Wyre Forest District Council Local Plan (2016-2034) Preferred Options: Constraints and Opportunities Analysis.

Preliminaries

In June 2017, as part of the Review of the emerging Local Plan (2016-2034), Wyre Forest District Council (WFDC) undertook a public consultation on the Preferred Options, which includes a number of proposed 'Core' sites, accompanied by an additional number of proposed allocations identified as 'Option A' and 'Option B' sites.

WFR/ST/9 Cursley Distribution Park

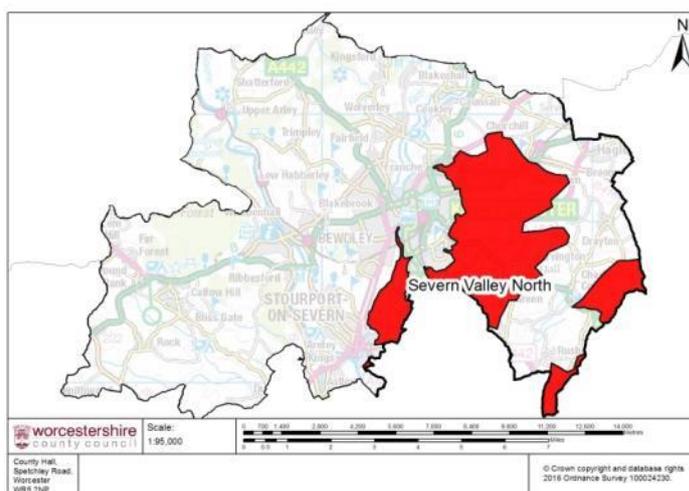
This site could accommodate low density development although only on the basis that it is already impacted upon by the visually intrusive warehouses. This is an open, arable landscape not associated with woodland. However, any new development will need to address visual impact through a landscape scheme that includes linear features and street trees to soften the development's impact to local receptors. There appears to be limited ecological interest and there do not appear to be any ecological constraints to allocation here. However, any subsequent planning application will need to be supported by appropriate surveys. There is a culverted watercourse that discharges through this site, near the eastern boundary, parallel to the road. Improvements should be made such as opening

up the culvert. There have been flooding issues in the past associated with this culvert and opening up the culvert may assist in addressing these issues and re-naturalising the brook.

WA/KF/2 Land off Ferndale Crescent

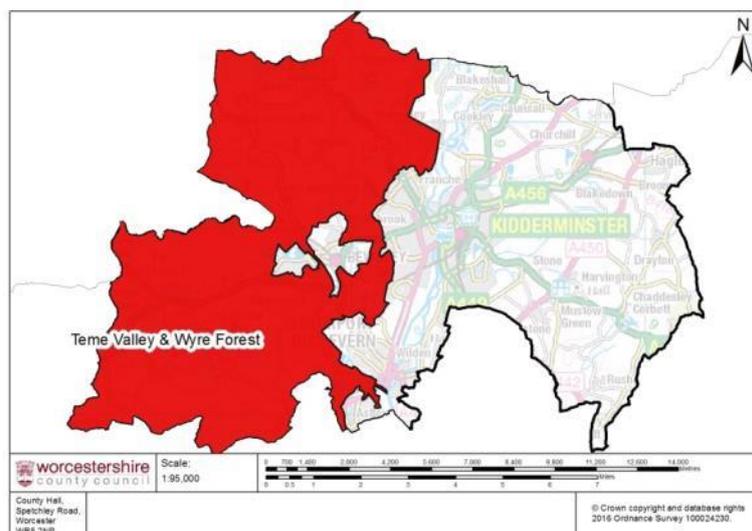
This is a sensitive location that will impact on views to Habberley Valley NR and receptors at Low Habberley; Sandy lane, Franche Estate and the A442. Mitigation should include screening, visual softening of settlement edge and varied housing density with lower density to the settlement edge.

WFR/WC/5 Gaymore Farm, Cookley

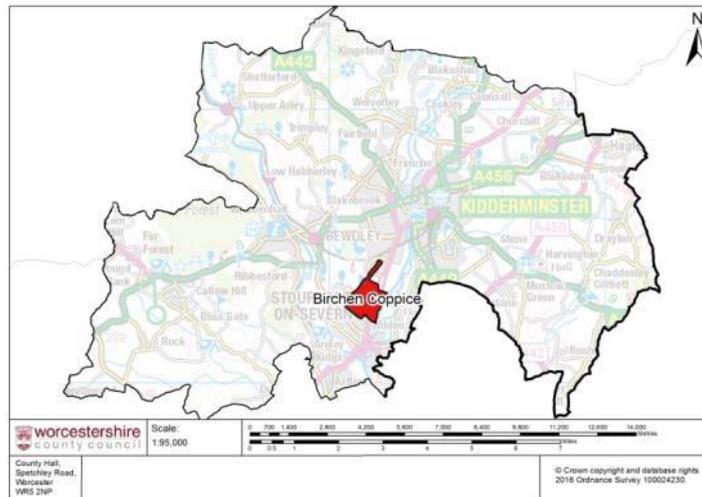
Development here would risk a significant impact to the setting of Gaymore Farm and the historic character of dispersed settlement.

LI/1 - Ceramaspeed

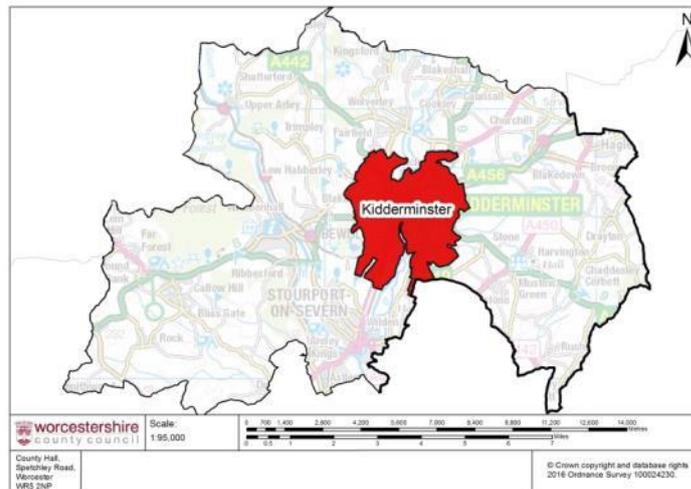
The existing site margins are sensitive to loss of trees and hedging, great care will be required in buffering the adjacent LWS. Conversely, opportunities should be sought to enhance existing trees and boundaries through appropriate planting to provide effective connectivity to the wider woodland character and nearby LWS. This existing screening should be retained and enhanced to mitigate urban to rural transition.

MI/37 Harriers Training Ground

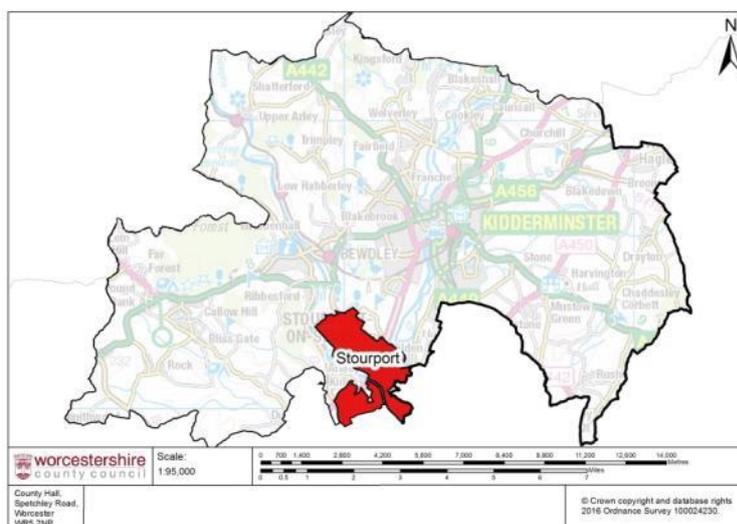
This site contributes to the local green network and in spite of impacts caused by nearby development it has value. Accordingly any allocation here will need to carefully consider mitigation and enhancement for any GI losses. The site will form a new gateway development and is a significant encroachment into the remaining Greenbelt between Kidderminster and Stourport. Loss of visual separation and light pollution will be particular issues.
